ADDENDUM NO. 2

MARKET STREET IMPROVEMENTS and FIFTH STREET ACTIVE TRANSPORTATION STP-5507(607) & TAP-5445(613)

COUNTY OF JEFFERSON, MISSOURI

April 13, 2026

TYPICAL SECTIONS

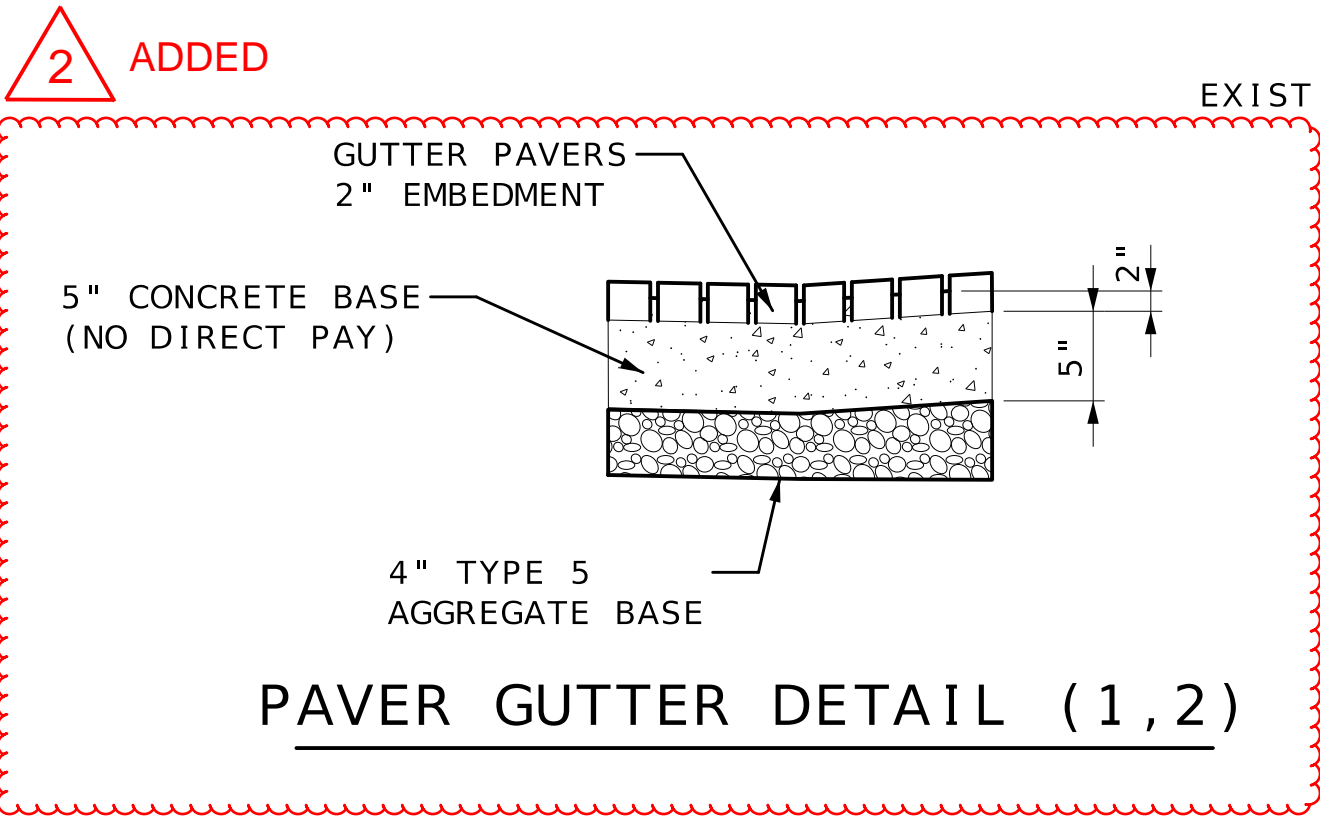
STP-5507(607) Updated Plan Sheet for Market Street Improvements: There is one (1) plan sheet being updated. Typical Sections Sheet 1 of 1 was updated to show the Paver Gutter Detail. This detail shows a 2" embedment depth of the Gutter Pavers, which was not in the original plan set.

PAVER GUTTER DETAIL (2)

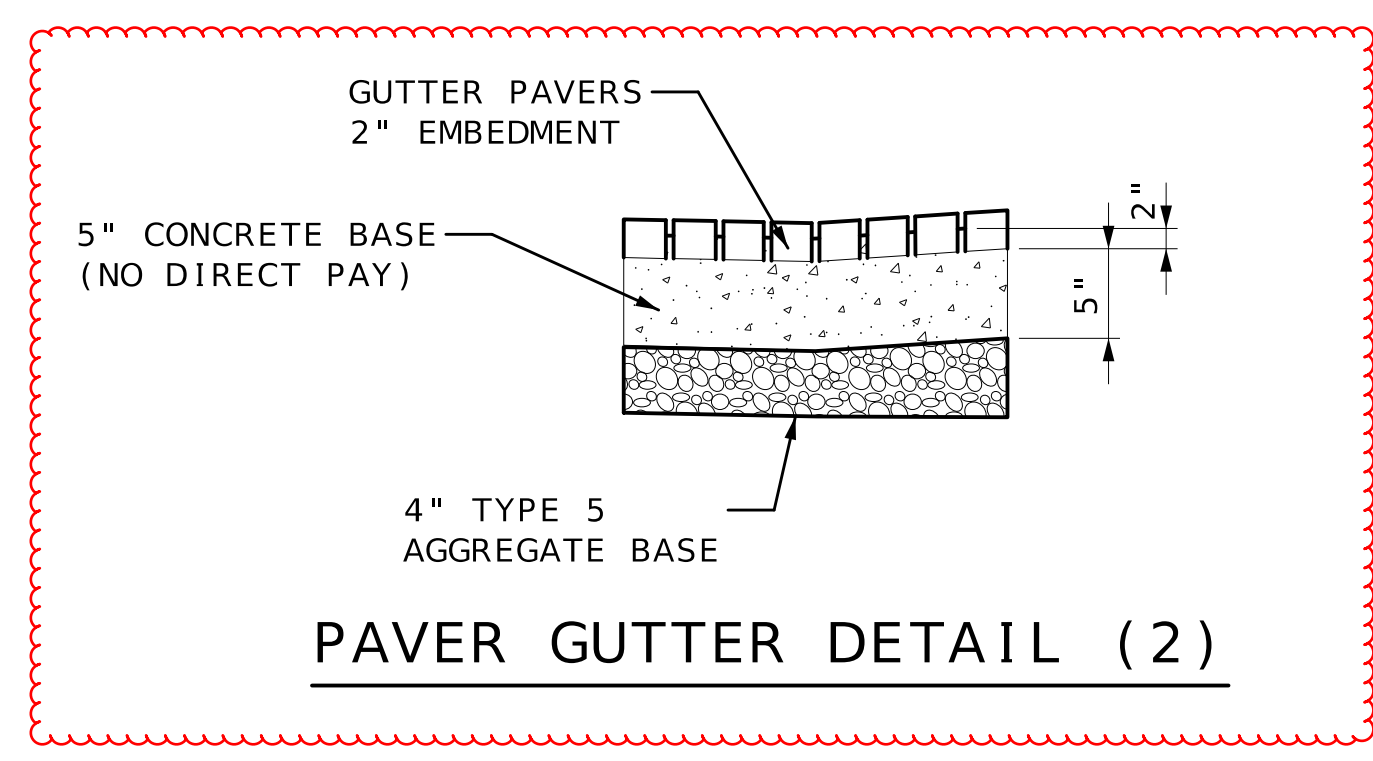
TAP-5445(613) Updated Plan Sheets for Fifth Street Active Transportation: There is one (1) plan sheet being updated. Typical Sections Sheet 2 of 2 was updated to show the Paver Gutter Detail. This detail shows a 2" embedment depth of the Gutter Pavers, which was not in the original plan set.
